**APPLICATION OF SOUTHERN CALIFORNIA GAS COMPANY FOR AUTHORITY TO RECOVER
VENTURA COMPRESSOR MODERNIZATION PROJECT REVENUE REQUIREMENT IN
CUSTOMER RATES AND FOR APPROVAL OF RELATED COST ALLOCATION AND RATE
DESIGN PROPOSALS (A.23-08-019)
(DATA REQUEST CAUSE-SCG-02)**

Date Requested: October 25, 2023, Submitted: November 10, 2023

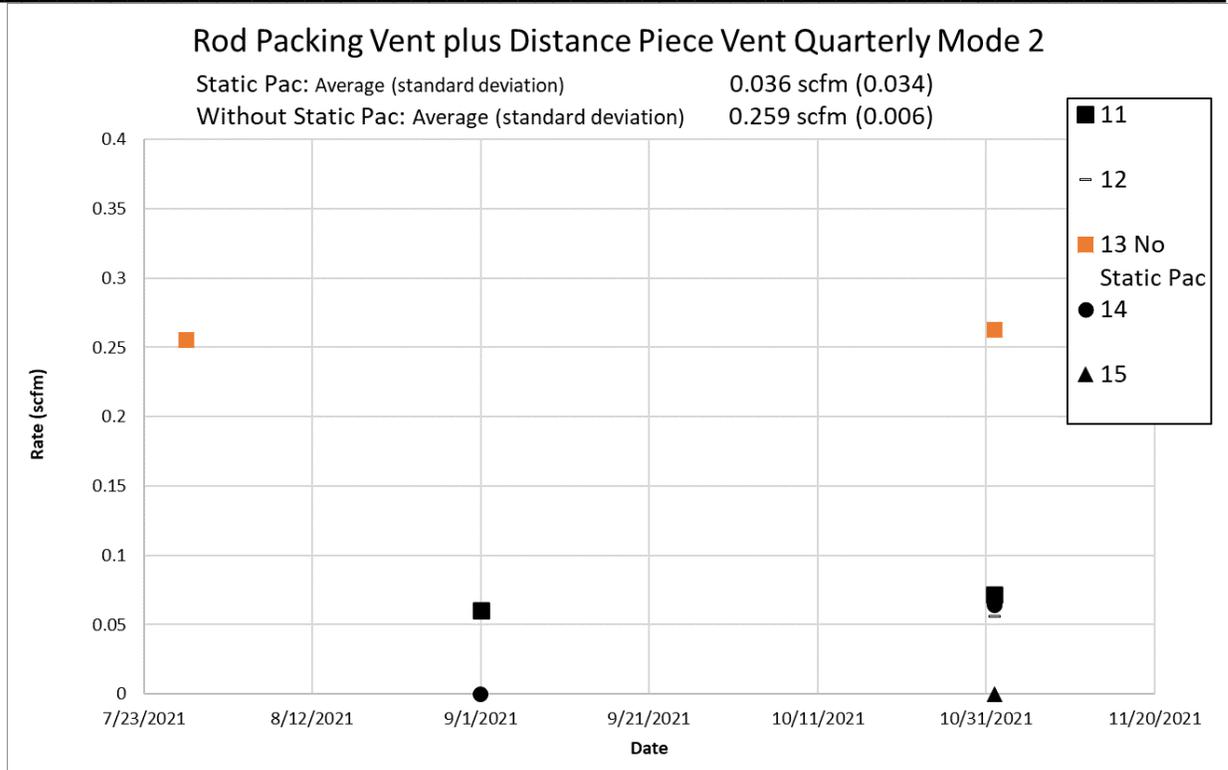
- a. Please provide examples where this same technology has been used, particularly in SoCalGas operated facilities.
- b. Please provide the calculations and full methodology for claiming that 85-100% of natural gas released into the atmosphere during venting will be prevented.

- a. SoCalGas has installed a Static-Pac packing system which is an emission reduction system at its Blythe Compressor Station at Blythe, CA.
- b. The manufacturer of Static Pac, Cook Compression, specifies up to 96% reduction can be achieved. See "Payback Analysis" at the bottom of Page 2 of the Static Pac brochure cookcompression.com/en/products/packing-cases/static-pac-shutdown-seals.html. The brochure is available at the bottom of this page and is attached. At the Blythe Compressor Station, SoCalGas measured venting from the Static Pac on Units 11, 12, 14, and 15 using the methodology described in the California Air Resources Board (CARB) Oil and Gas Rule (arb.ca.gov/resources/documents/oil-and-gas-regulation) and compared it to venting on Unit 13 that does not have Static Pac. As shown in the graph below, the average reduction with Static Pac was 85% is in alignment with manufacturer expected reduction.
